Project	<b>IEEE 802.16 Broadband Wireless Access Working Group</b> < <a href="http://ieee802.org/16">http://ieee802.org/16</a> >
Title	<b>Correction of U-TDOA Measurement Procedure</b>
Date Submitted	<b>2006-11-15</b>
Source(s)	Jaesun Cha, Kwangjae Lim, and, Chulsik Yoon <a href="mailto:jscha@etri.re.kr">jscha@etri.re.kr</a> ETRI 161 Gajeong-dong, Yuseong-gu Daejeon 305-700 Korea
Re:	Contribution on comments to IEEE 802.16g/D5
Abstract	Correction of U-TDOA Measurement Procedure
Purpose	Adoption
Notice	This document has been prepared to assist IEEE 802.16. It is offered as a basis for discussion and is not binding on the contributing individual(s) or organization(s). The material in this document is subject to change in form and content after further study. The contributor(s) reserve(s) the right to add, amend or withdraw material contained herein.
Release	The contributor grants a free, irrevocable license to the IEEE to incorporate text contained in this contribution, and any modifications thereof, in the creation of an IEEE Standards publication; to copyright in the IEEE's name any IEEE Standards publication even though it may include portions of this contribution; and at the IEEE

Figure G3 – UTDOA Measurement Algorithm

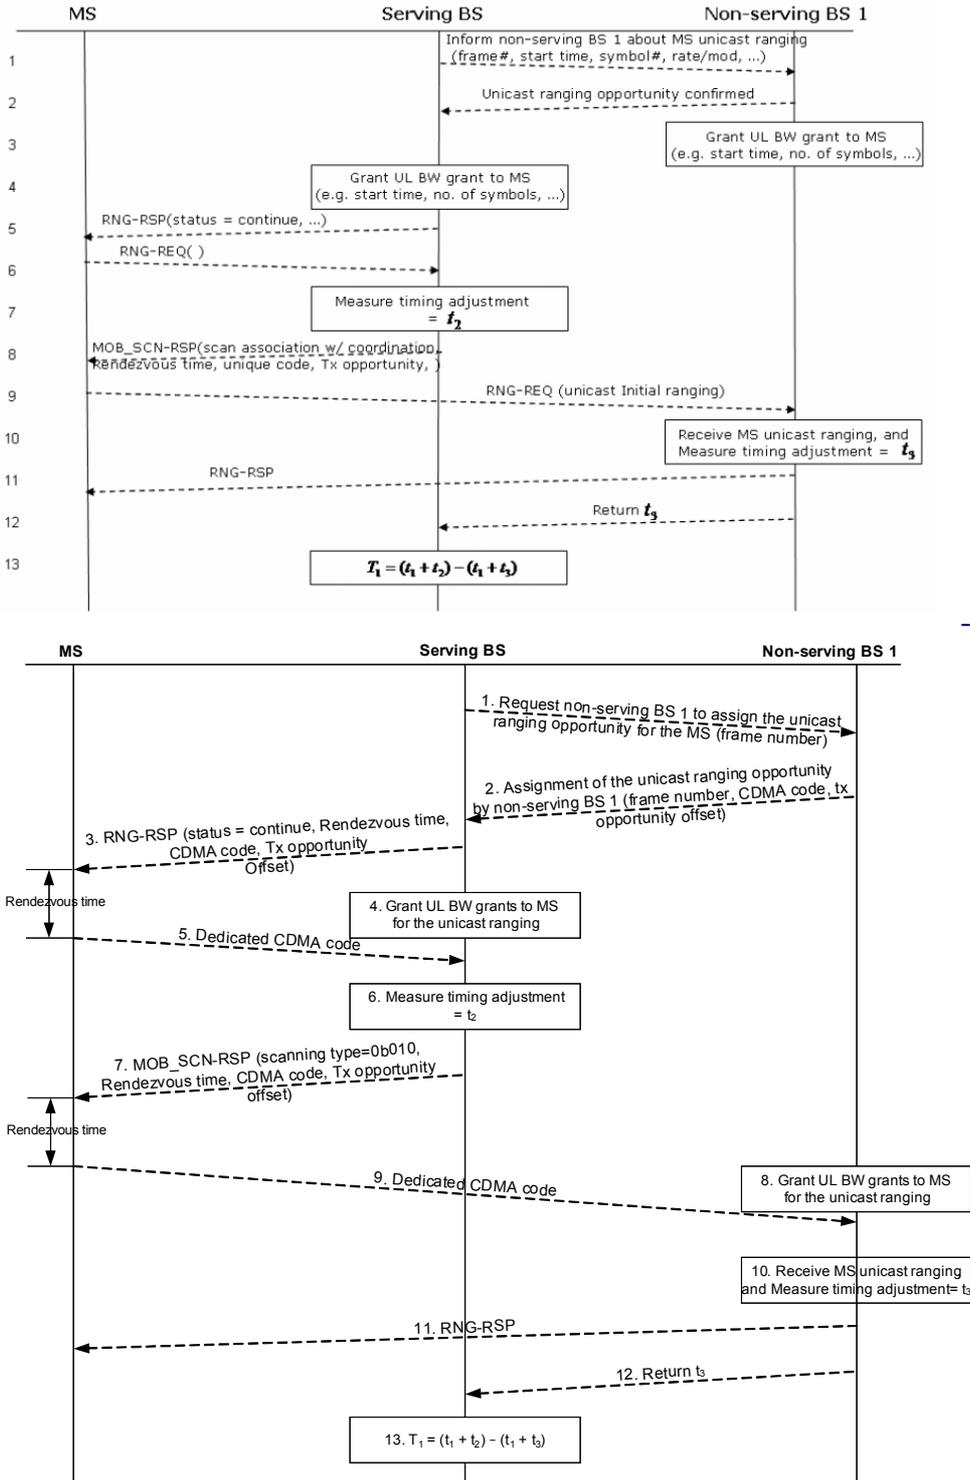
8. ~~Serving BS sends autonomous MON\_SCN-RSP with scanning type = 0b10 (scan association with coordination) to force MS performing initial ranging after scan~~

9. ~~MS synchronized with non-serving BS 1, and sends RNG-REQ~~
  10. ~~Non-serving BS 1 receives unicast ranging, and measures Timing Adjustment  $t_3$~~

11. ~~Non-serving BS returns RNG-RSP to MS~~
  12. ~~Non-serving BS returns  $t_3$  to serving BS~~
  13. ~~Serving BS reads the Timing Advance  $t_1$  that was captured previously, and calculate U-TDOA~~

1. Serving BS requests non-serving BS 1 to assign the unicast ranging opportunity for the MS.
  2. Non-serving BS 1 confirms the allocation of the unicast ranging opportunity for the MS and returns the related parameters

- Frame number
    - CDMA code
    - Transmission opportunity offset
  3. Serving BS sends an autonomous RNG-RSP message to ask MS performing unicast ranging. The unicast ranging information is included in RNG-RSP message.

- Rendezvous time
    - CDMA code
    - Transmission opportunity offset
  4. Serving BS allocates a UL slot for MS to do unicast ranging which means “dedicated ranging indicator” bit of the UL-MAP IE shall be set to 1.

5. When MS receives the RNG-RSP from serving BS, it shall send the allocated CDMA code at the assigned slot.
  6. Serving BS 1 measures Timing Adjustment  $t_2$

7. Serving BS sends autonomous MOB\_SCN-RSP with scanning type = 0b10 (scan association with coordination) to force MS performing initial ranging after scan.

- Rendezvous time
    - CDMA code
    - Transmission opportunity offset
  8. Non-serving BS 1 grants UL slot to the MS and sets “dedicated ranging indicator” bit of the UL-MAP IE to 1 to use the allocated region for the purpose of unicast ranging.

9. After the rendezvous time from the reception of the MOB\_SCN-RSP, MS synchronized with non-serving BS 1, and sends the allocated CDMA code at the allocated transmission opportunity offset.

10. Non-serving BS 1 receives unicast ranging, and measures Timing Adjustment  $t_3$
  11. Non-serving BS returns RNG-RSP to MS
  12. Non-serving BS returns  $t_3$  to serving BS

13. Serving BS reads the Timing Advance  $t_1$  that was captured previously, and calculate U-TDOA

Figure G5 – U-TDOA Measurement Algorithm

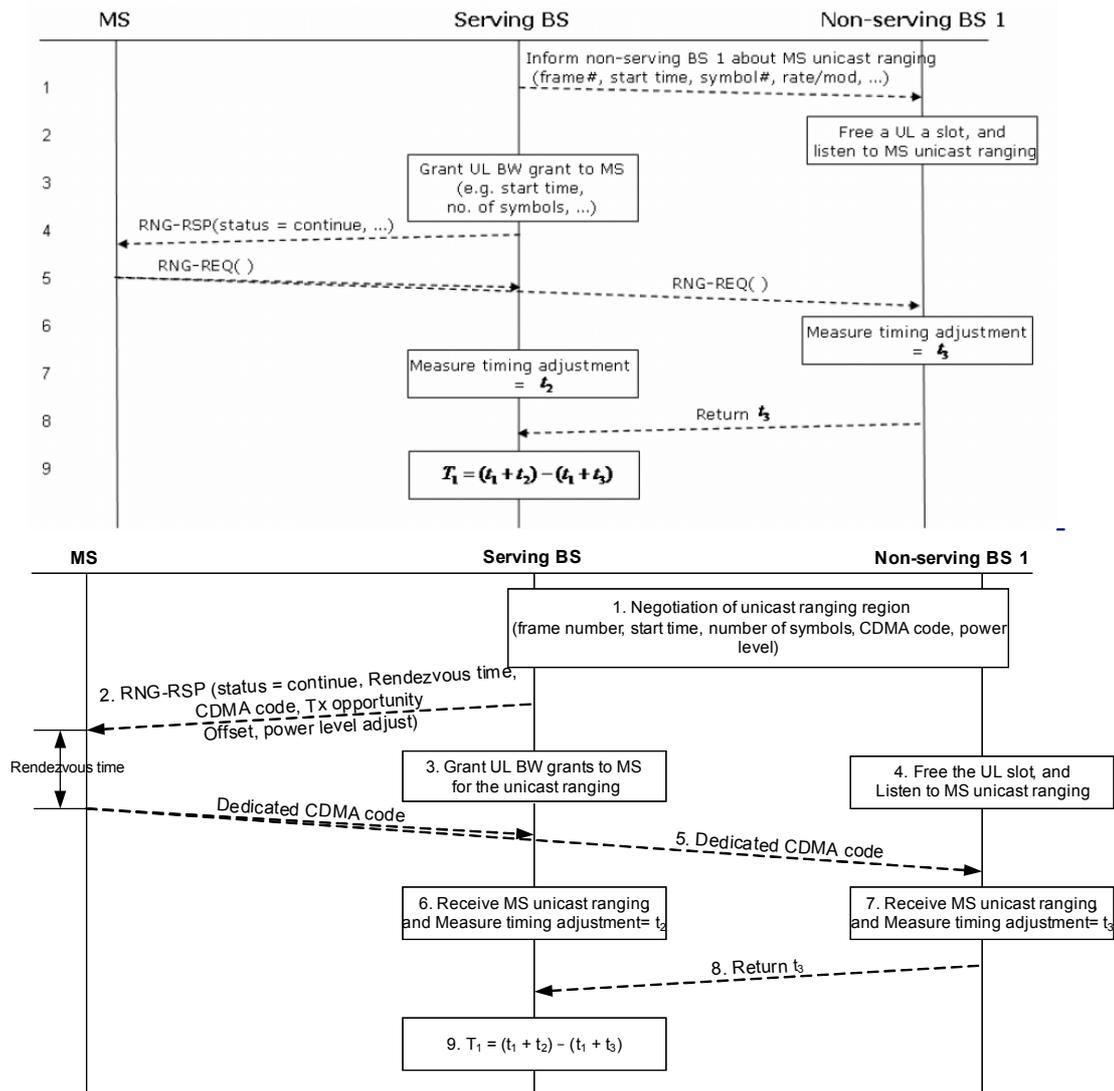
1. ~~Serving BS informs non-serving BS 1 about MS is going to do unicast ranging by passing frame number, start time, number of symbols,~~
  2. ~~Non-serving BS 1 does not grant such UL slot to the MS, and listens to the unicast ranging from MS~~

3. ~~Serving BS allocates a UL slot for MS to do unicast ranging.~~
  4. ~~Serving BS sends an autonomous RNG-RSP message to ask MS performing unicast ranging~~

5. ~~When MS receives the RNG-RSP from serving BS, it shall send RNG-REQ at the assigned slot that can be received by non-serving BS.~~
  6. ~~Non-serving BS 1 measures Timing Adjustment  $t_3$ .~~

7. ~~Serving BS measures Timing Adjustment  $t_2$~~
  8. ~~Non-serving BS 1 returns  $t_3$  to serving BS~~
  9. ~~Serving BS reads the Timing Advance that was captured previously, and calculates U-TDOA~~

1. Serving BS and non-serving BS 1 negotiate the allocation of the unicast ranging region for the MS.
    - Frame Number
    - Number of symbols
    - CDMA code

- Power level

2. The serving BS sends an unsolicited RNG-RSP message to ask MS performing the unicast ranging. The unicast ranging information is included in the RNG-RSP message.

- Rendezvous time
  - CDMA code
  - Transmission opportunity offset
3. The serving BS allocates a UL slot for MS to do unicast ranging at the pre-assigned rendezvous time and listens to the unicast ranging from the MS.

4. At the same time, the non-serving BS 1 does not grant such UL slot to any MSs at the pre-assigned rendezvous time and listens to the unicast ranging from the MS.

5. When the MS receives the unsolicited RNG-RSP from the serving BS, it shall send the dedicated CDMA code at the assigned slot. The transmission power shall be changed based on the power level adjust parameter included in the receive RNG-RSP message to allow the non-serving BS to receive the code successfully.

6. The non-serving BS 1 measures Timing Adjustment  $t_3$
7. The serving BS measures Timing Adjustment  $t_2$
8. The non-serving BS 1 returns  $t_3$  to serving BS

9. The serving BS reads the Timing Advance that was captured previously, and calculates U-TDOA
